Fourth Quarter 2004 Progress Report
Midwest Roadside Safety Facility
Mid-States Regional Pooled Fund
January 28, 2005

Pooled Fund Consulting Summary

Midwest Roadside Safety Facility
October 2004 – January 19, 2005

Figure 1. Vertical Shape Concrete Barrier

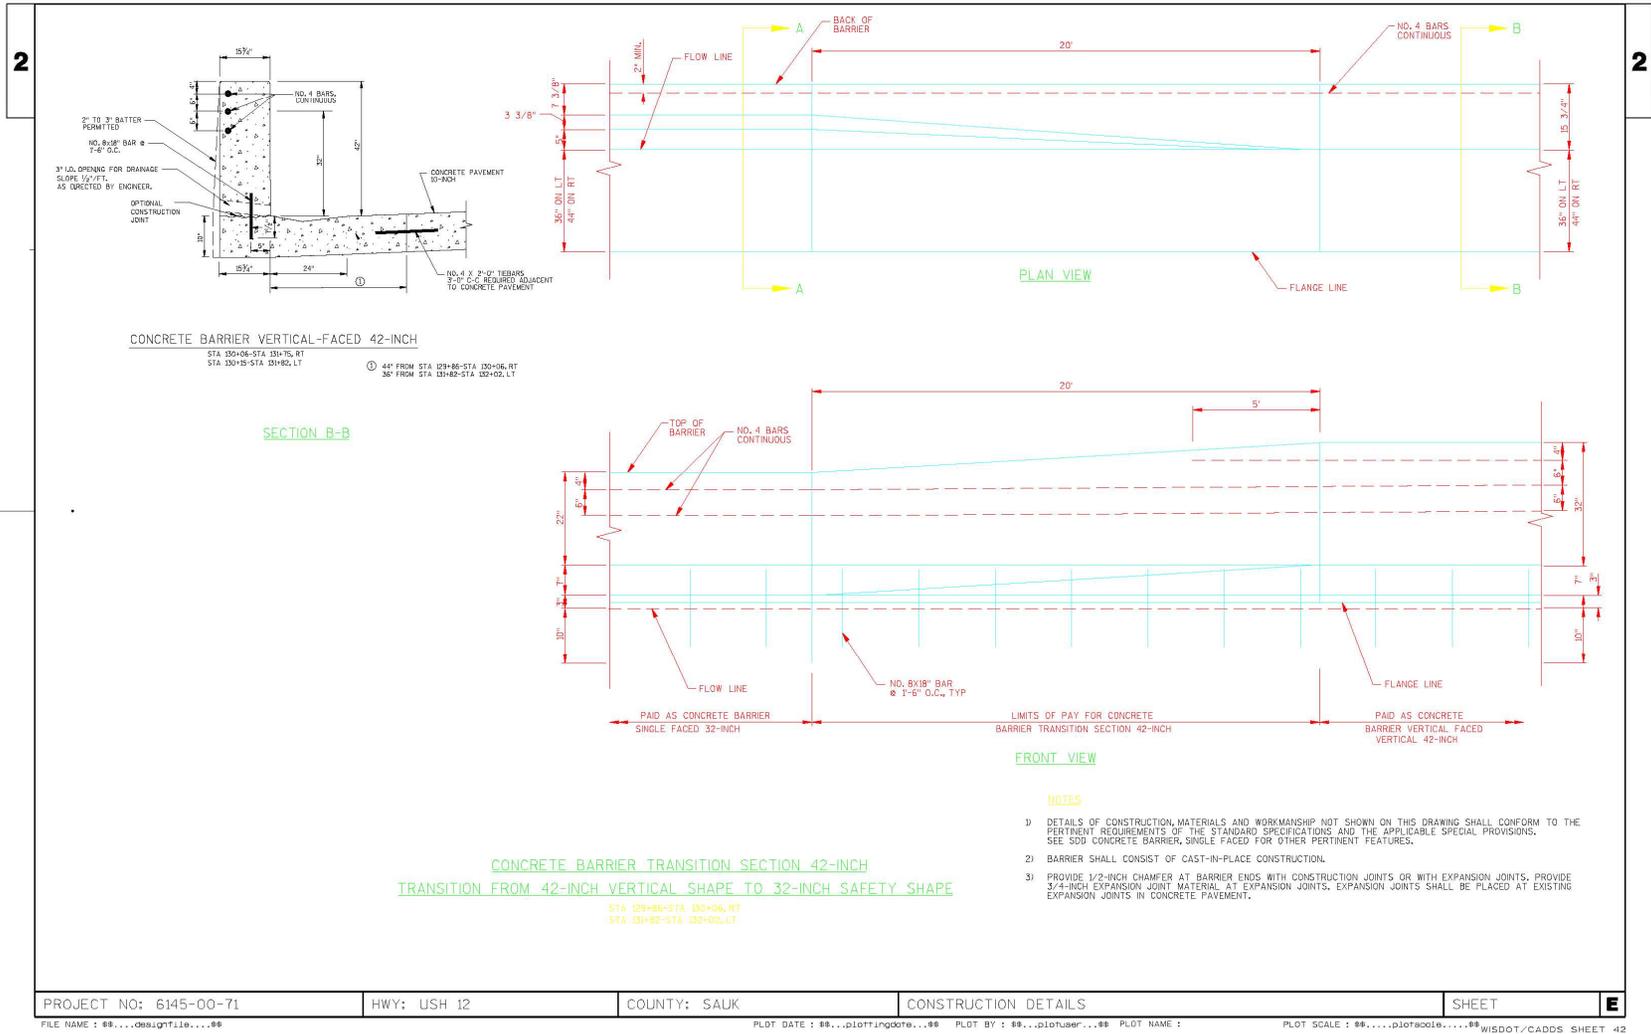
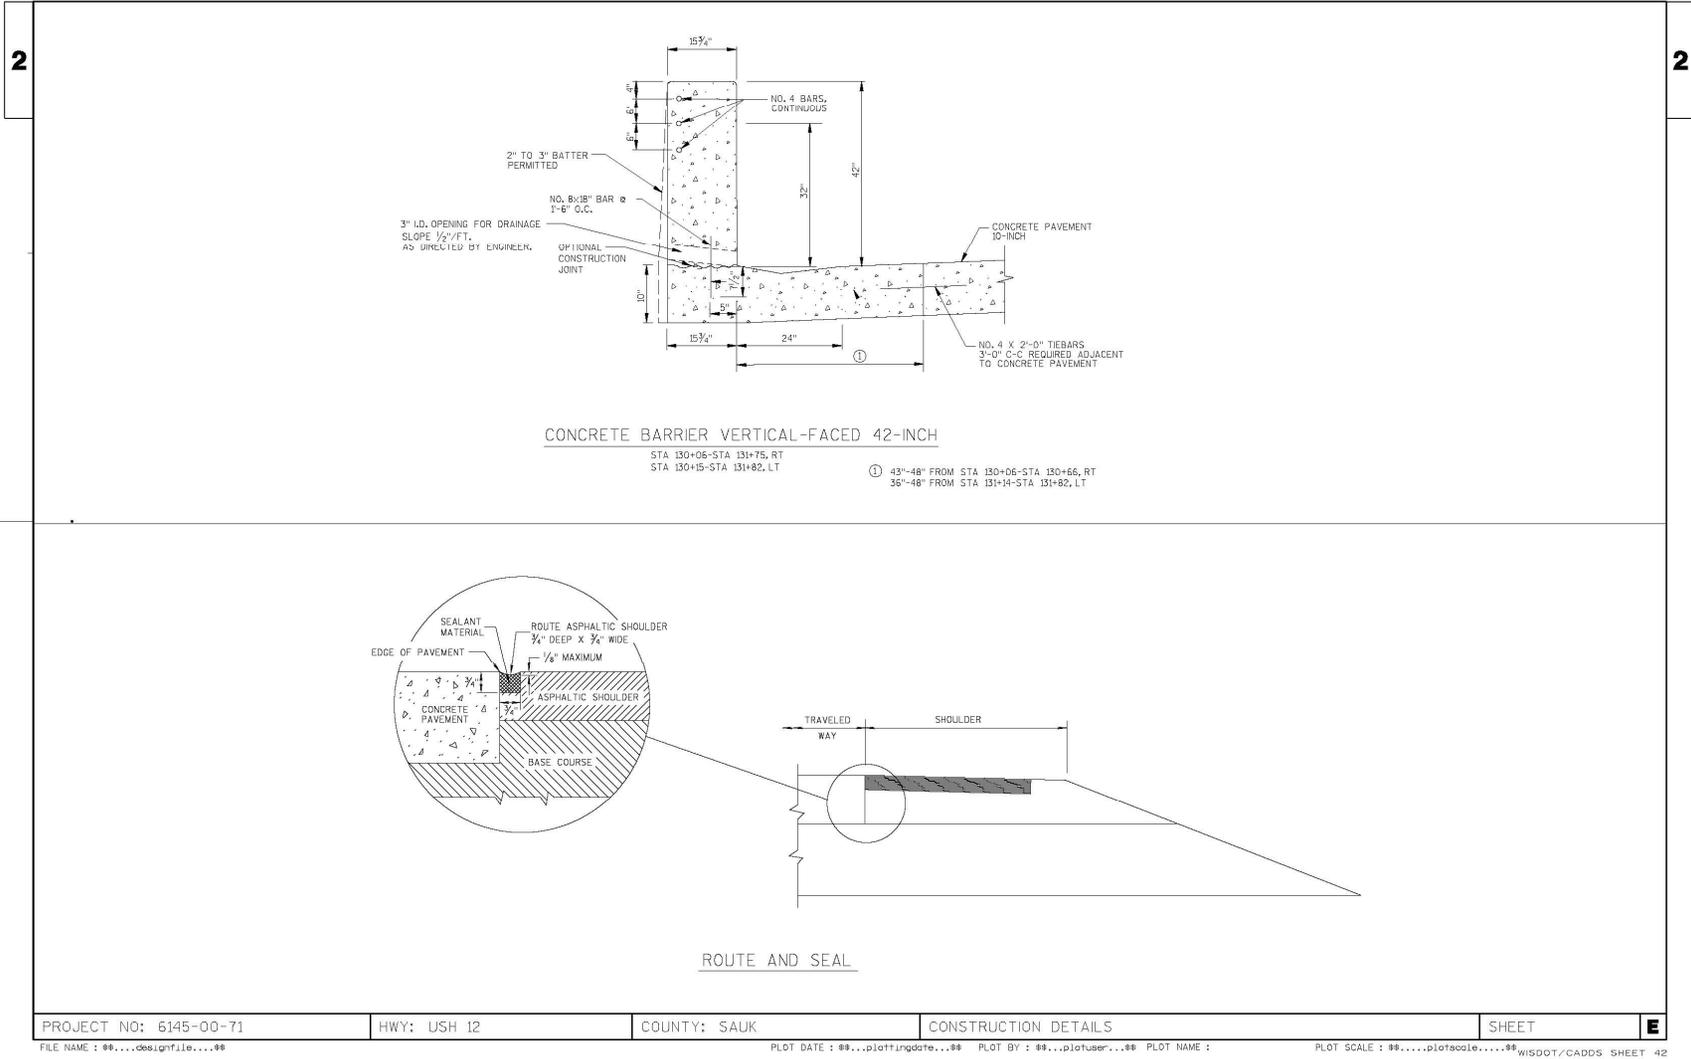
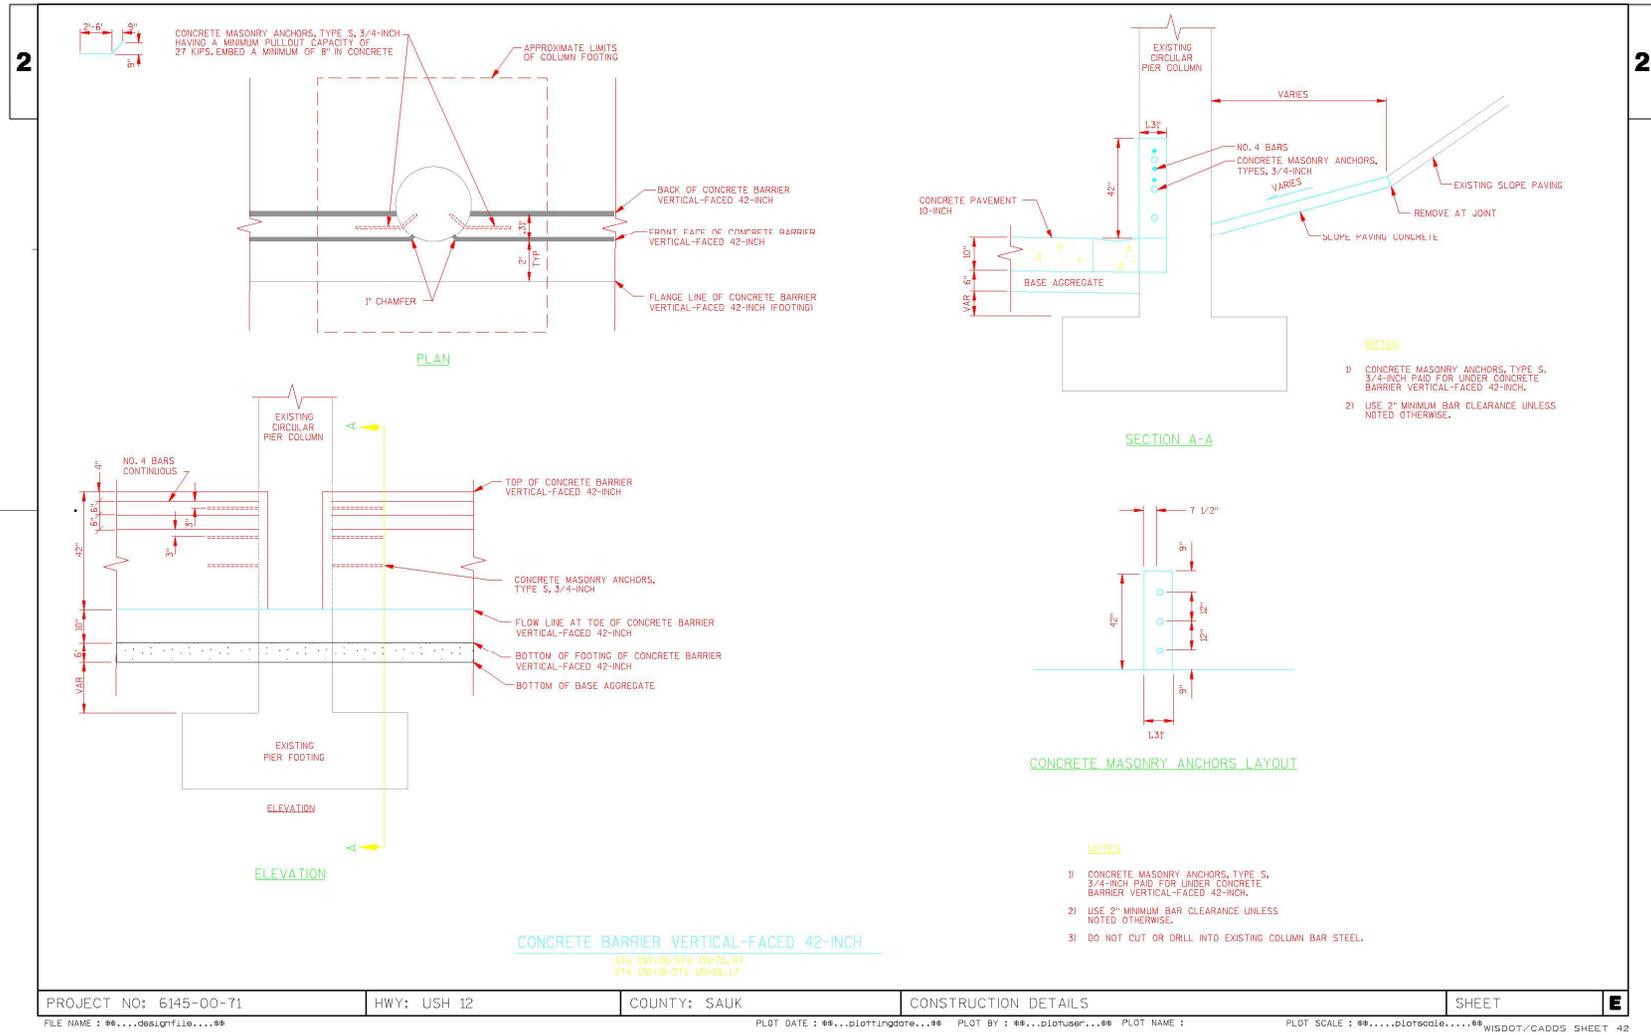
The proposed vertical concrete barrier is 15.75-in thick by 42-in. tall and reinforced by three longitudinal No. 4 rebars and anchored to an edge slab with No. 8 vertical dowel bars (10.5 in. in barrier and 7.5 in. in slab). The vertical dowel bars are spaced on 18-in. centers. It is my understanding that the Wisconsin DOT desires to use this barrier to protect bridge piers and needs the barrier to meet Test Level 3 of NCHRP Report 350.

From a very brief review, it is noted that the cross-sectional area of the thick barrier is 661.50 sq. in. Therefore, the approximate shrinkage and temperature steel requirements for longitudinal reinforcement is a minimum of 1.19 sq. in. Thus, approximately six No. 4 longitudinal bars, versus three, would be required for this large cross section in order to prevent significant cracking and gaps from forming in the barrier. Although not determined, it is very likely that a 15.75-in. wide barrier measuring 42-in. tall would be capable of meeting the TL-3 requirements when reinforced with six longitudinal No. 4 bars for interior locations. In addition, if designed using the yield-line analysis procedures, it is believed possible to further reduce the thickness and still not require crash testing. At the present, there exists no vertical reinforcement in the barrier. Although it has been shown on occasion that concrete barriers with limited or no reinforcement have met crash testing guidelines, it is reasonable to utilize a minimum amount of vertical reinforcement for temperature and shrinkage considerations as well as to tie the wall to the dowel bars. Steel reinforcement for the barrier located away from the interior regions, such as

at gaps, joints, or end sections, must also be considered since a reduced redirective capacity exists in those regions.

For 42-in. tall vertical walls, it is becoming more known that new designs should address or consider the potential for an occupant's head to extend out of the side window and impact the concrete barrier above the 32-in. height. Thus, setbacks near the top of the wall should be considered although they are not required.
